SUBJECT: Triangle Expressway Southeast Extension (Complete 540) from NC 55 Bypass in Apex to US 64/264 (I-87) in Knightdale, Wake and Johnston Counties; Federal Aid No. STP-0540(19), STP-0540(20), and STP-0540(21); WBS Nos. 37673.1.TA1, 35516.1.TA1, and 35517.1.TA1; STIP Project Nos. R-2721, R-2828, and R-2829

Also, please reference your November 25, 2025 email, requesting modification of the permit to authorize change of impacts at Permit Sites 14, 15, and 31, for R-2829B. The modifications at 14 and 15 are necessary for an alternate Neuse River bridge design that reduces the overall length of the bridge by 290 feet, saves approximately \$2 million in construction costs, reduces bridge construction time by 23 weeks (including short term impacts to the river and the Neuse River Greenway), and reduces required concrete truck trips by 262 loads.

The Corps has completed the evaluation of your request and has determined that it is appropriate and reasonable, and that no public notice is required for this modification. Therefore, the permit is modified as requested and as shown on the enclosed R-2829B Mod Permit Drawings, Sheets 1, 30-39, 76, and 110-112, submitted November 25, 2025.

PERMIT DRAWING
SHEET 30 OF 112

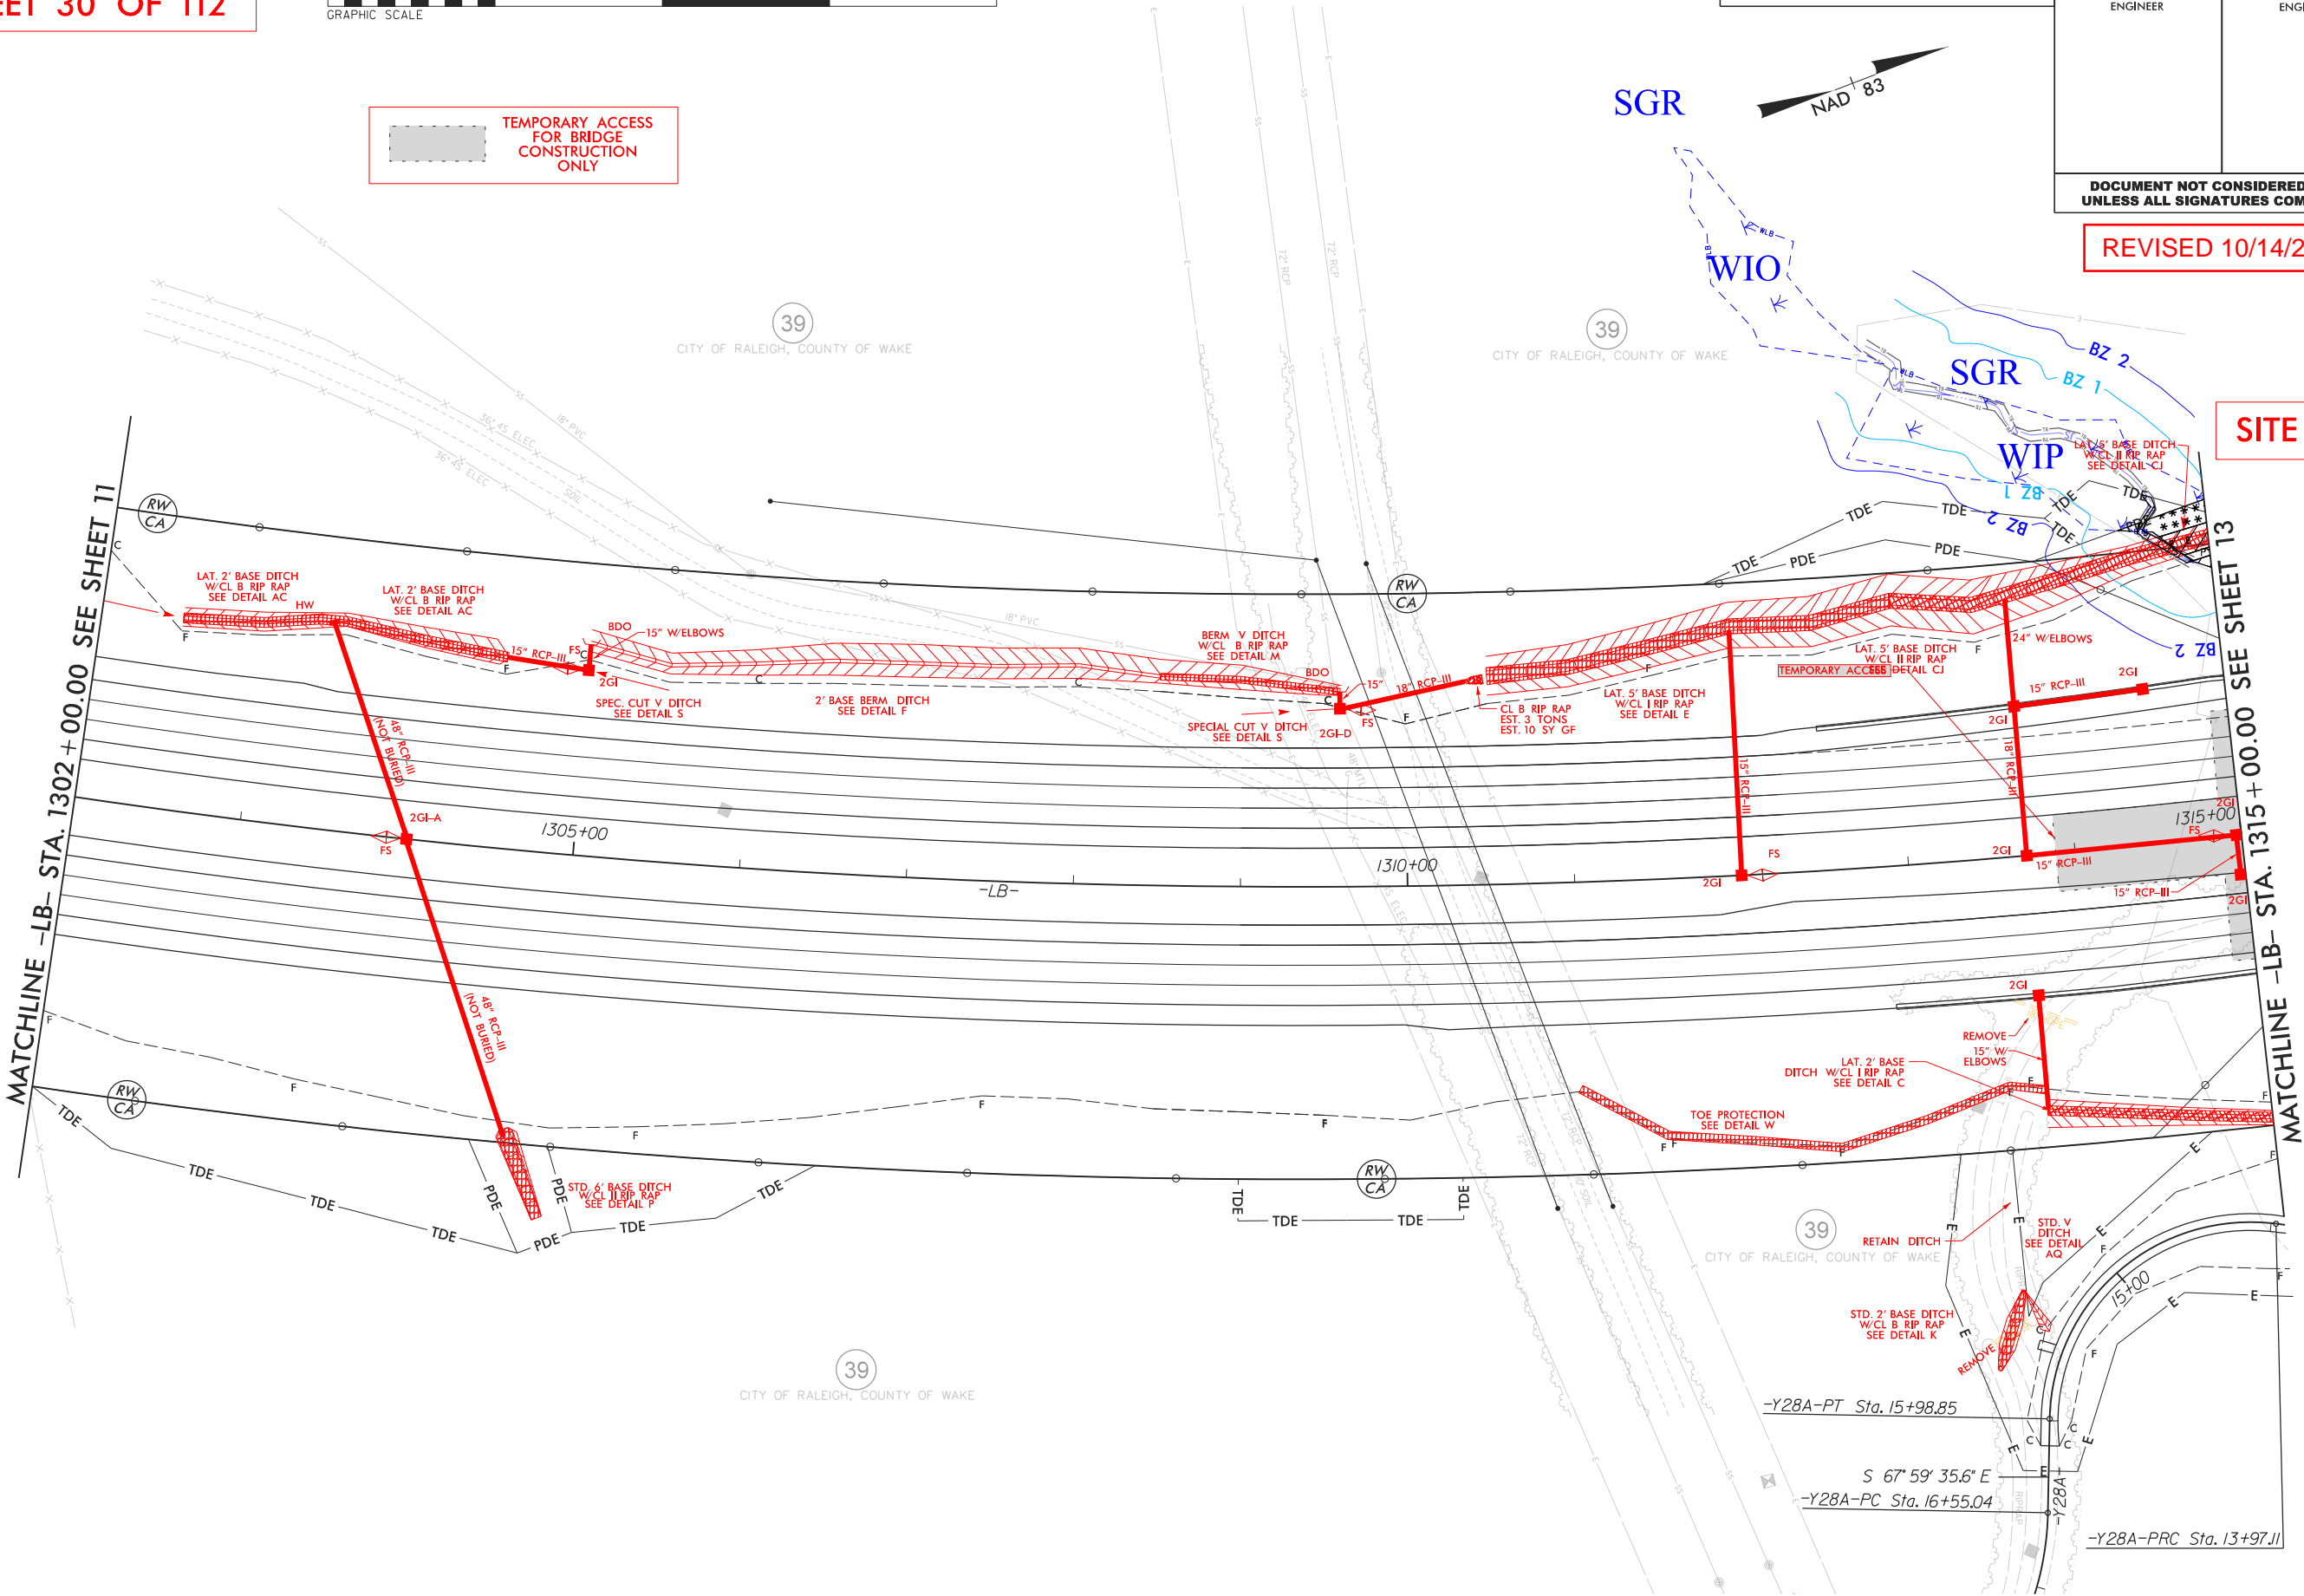
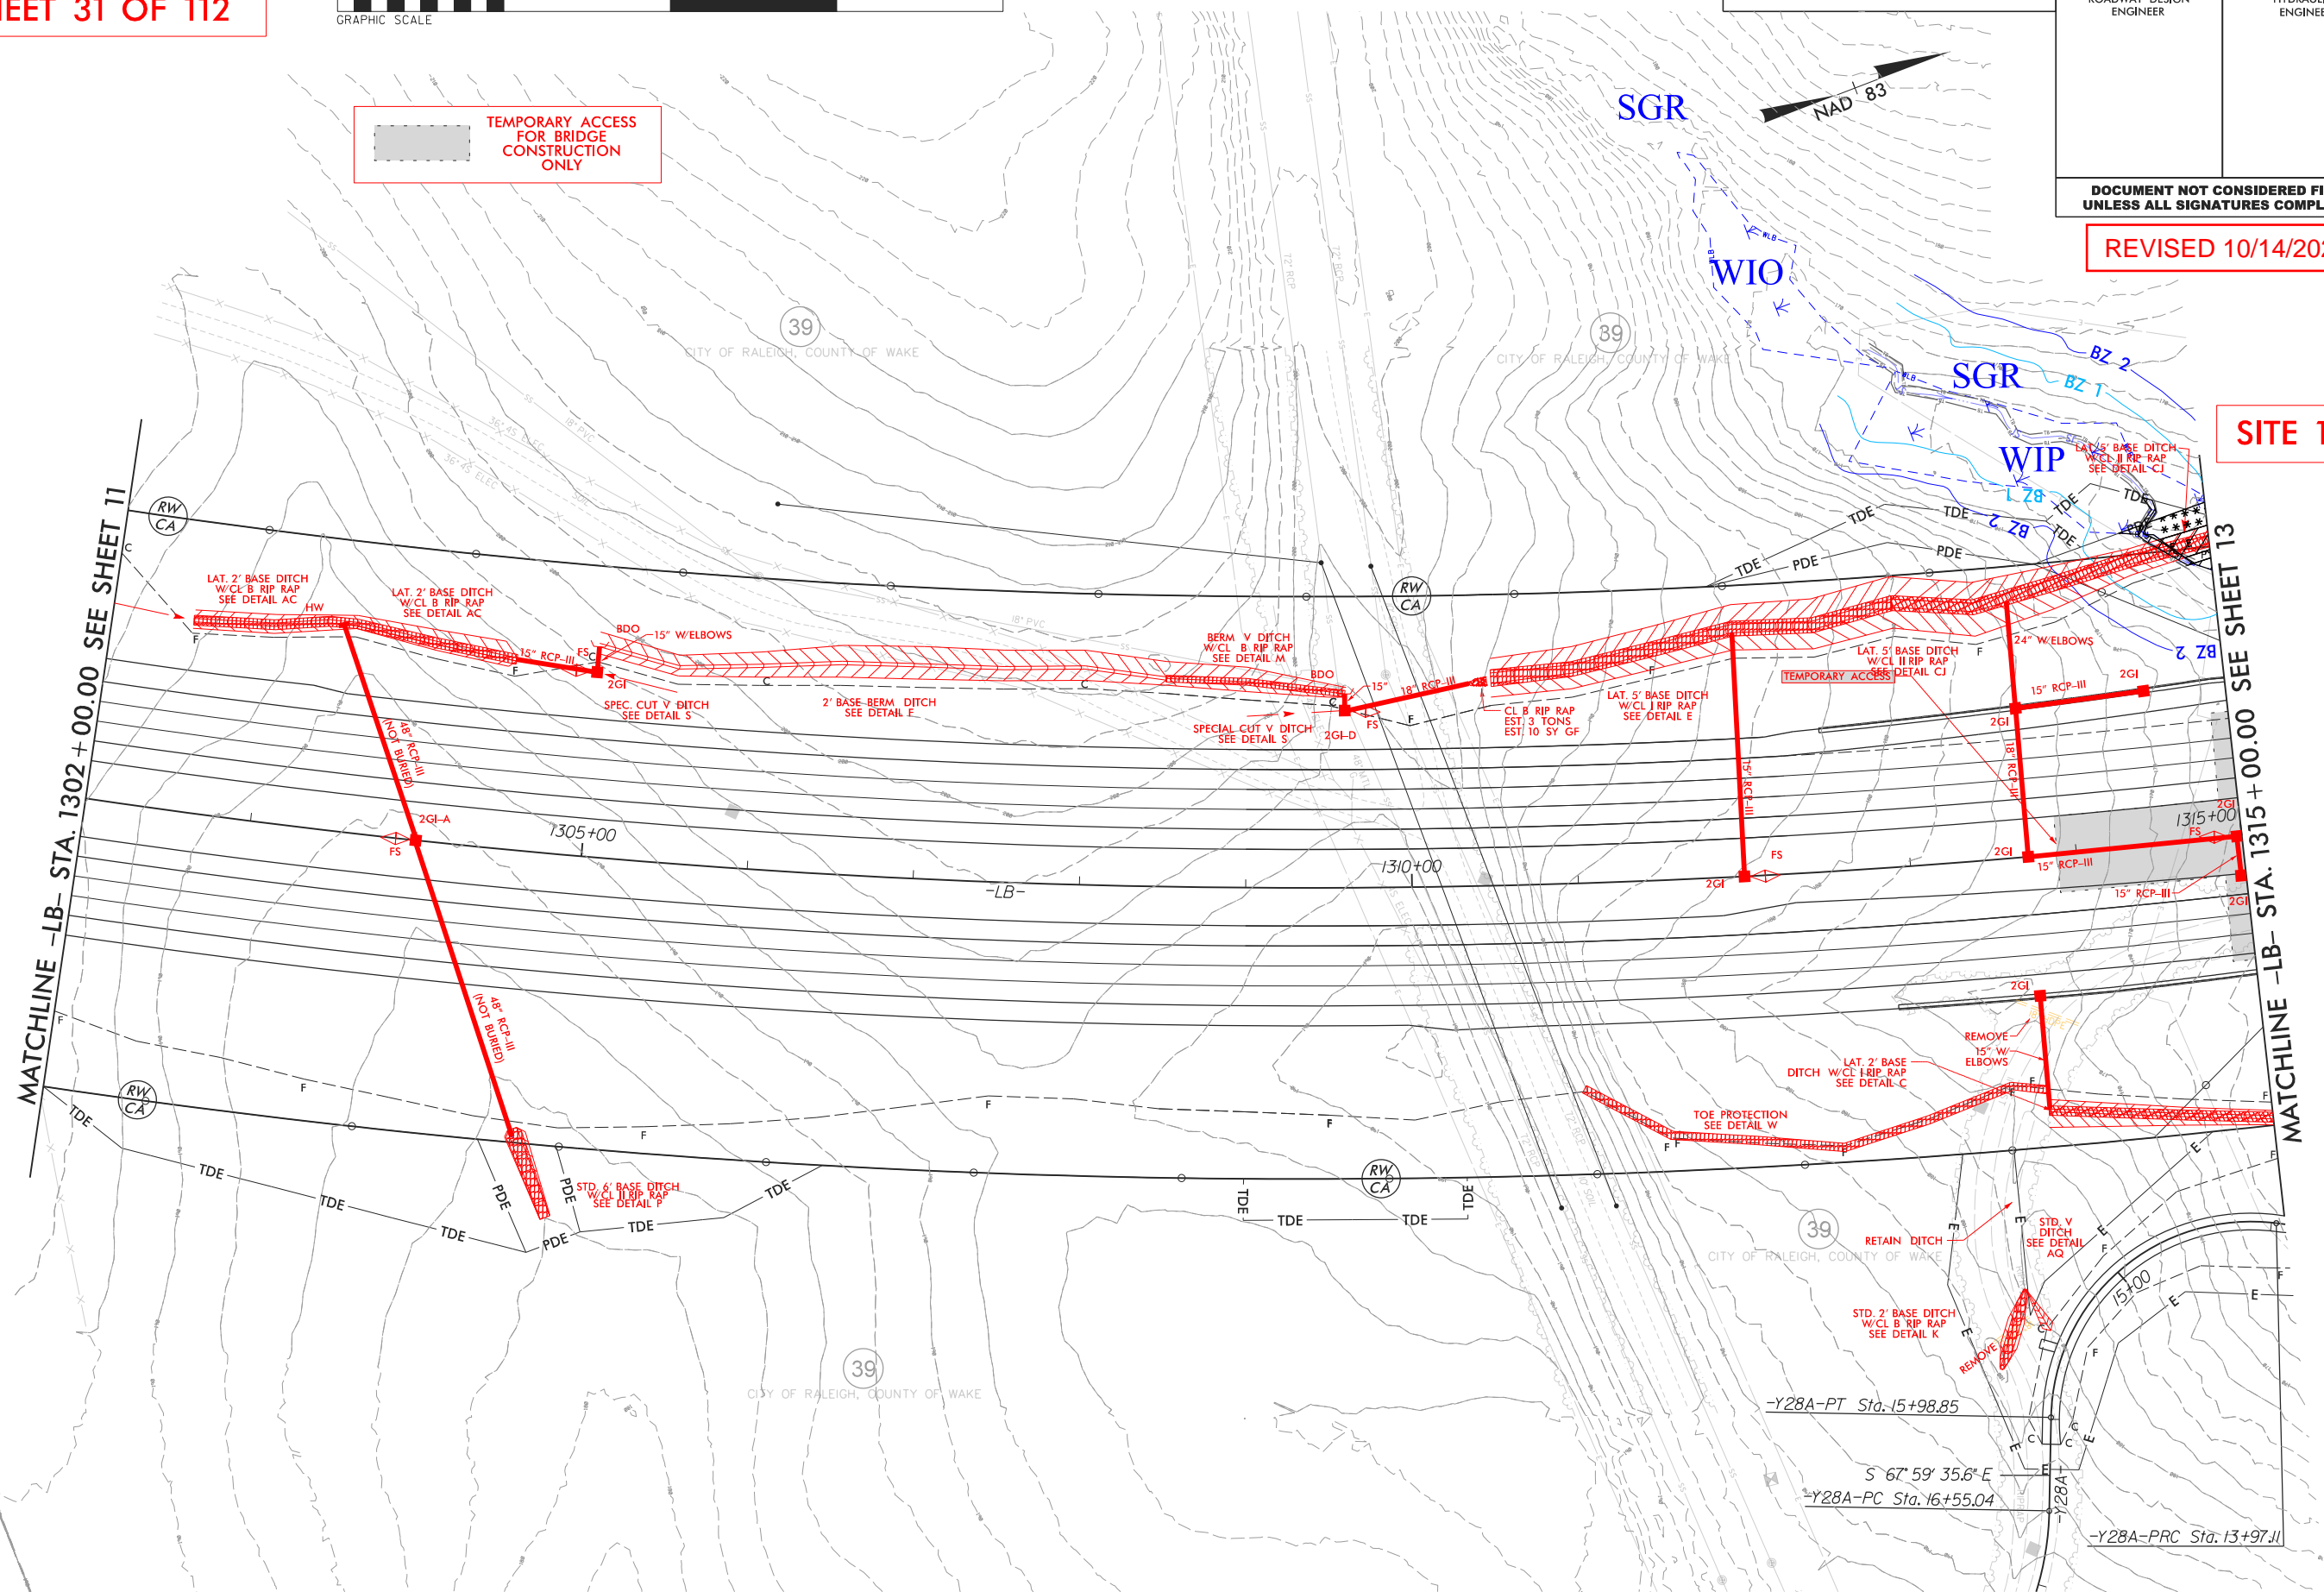
Site 14: Impacts from southern end bent relocation

- Fill in Wetland: 0.036 ac (previously 0 - increase of 0.036 ac)
- Excavation in Wetland: 0.021 ac (previously 0.002 - increase of 0.019 ac)
- Mechanized Clearing in Wetland: 0.030 ac (previously 0.011 - increase of 0.019 ac)
- Permanent Surface Water Impacts: 500 lf (previously 442 - increase of 58 lf)
